Technical Bulletin 205

02.2020

Item	Subject	Model Affected
205.1	Adaption Processes	All models with Fuel Injection
205.2	Airbox Parts Kit	Bonneville T100, Bonneville T100 Black, Street Twin, Street Scrambler

205.3	Fairing Assembly	Daytona MOT02™ 765
205.4	Vehicle Identification Number Description - from 1,000,000 (AA0001)	Bonneville T100 Black, Bonneville T100, Street Scrambler, Speed Twin 1200, Thruxton 1200 RS, Street Twin, Scrambler 1200 XC, Scrambler 1200 XE, Bonneville T120, Bonneville T120 Black, Bobber, Bobber Black, Bobber TFC, Bonneville Speedmaster, Bonneville T120 Bud Ekins, Bonneville T100 Bud Ekins, Tiger 1200 XR, Tiger 1200 XR, Tiger 1200 XCX, Tiger 1200 XRT, Tiger 1200 XCA, Tiger 1200 XR (LRH), Tiger 1200 Alpine, Tiger 1200 Desert, Tiger Sport, Speed Triple S, Speed Triple RS, Rocket 3 GT, Rocket 3 R, Rocket 3 TFC, Street Triple S 660 cc "LAMS", Street Triple 660cc A2 licence, Street Triple R, Street Triple R (LRH), Street Triple RS, Daytona MOT02™ 765, Tiger 900, Tiger 900 GT, Tiger 900 GT Pro, Tiger 900 GT (LRH), Tiger 900 Rally, Tiger 900 Rally Pro

Item: 205.2

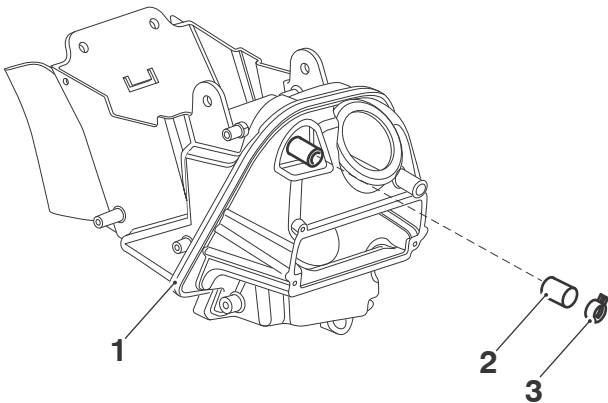
A new airbox has been introduced to the above models from VIN 968257 (all markets except Brazil, China and India) and from VIN 969083 (Brazil only) and is retrofittable. The new airbox has a secondary air injection spigot at the front for compatibility with other models or markets. When ordering a replacement airbox, a parts kit (part number T2203146) is available consisting of an airbox assembly, a plastic cap and a hose clip.

The plastic cap and hose clip must be fitted before assembling the airbox to the motorcycle.

- 1. Airbox assembly
- 2. Plastic cap
- 3. Hose clip

Exploded View - Fairing

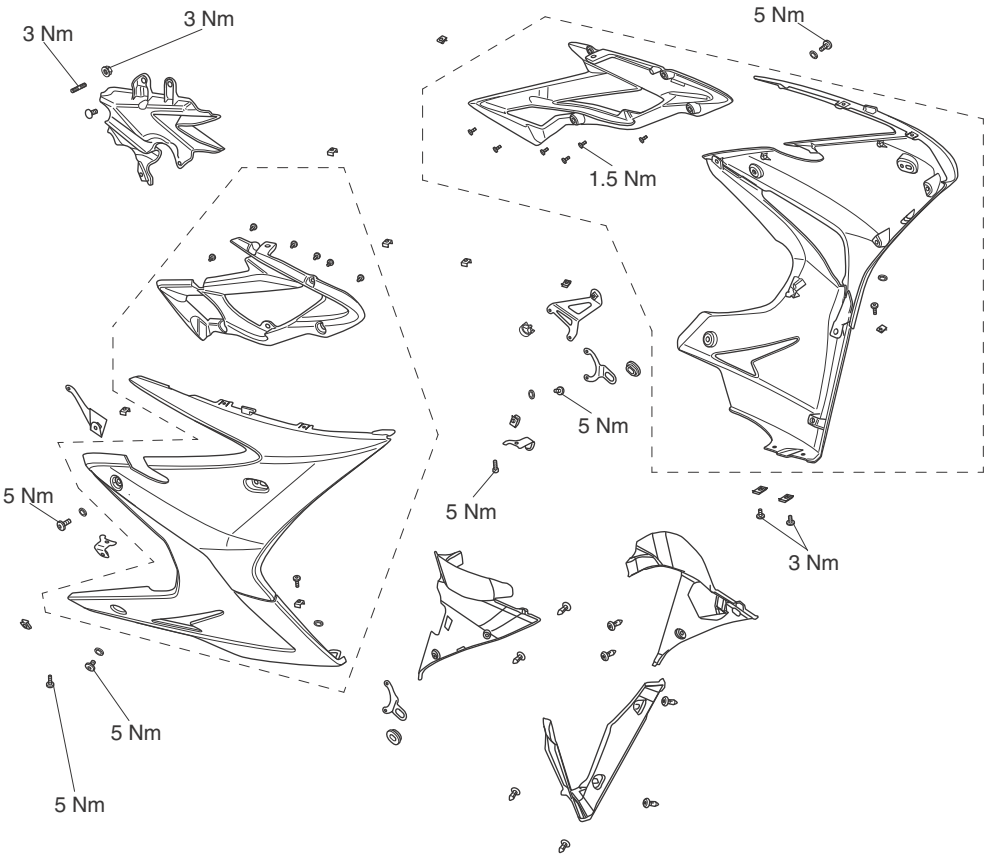
Due to the precise manufacturing methods of the fairing assembly on the above models, a new fairing will only be supplied in a subassembly consisting of an upper and lower fairing and fairing infill.
The upper and lower fairing are a matched pair and must not be separated.
The fairing infills (RH part number 2309460, LH part number 2309457) are also available as a separate item.
A revised installation method is described below.
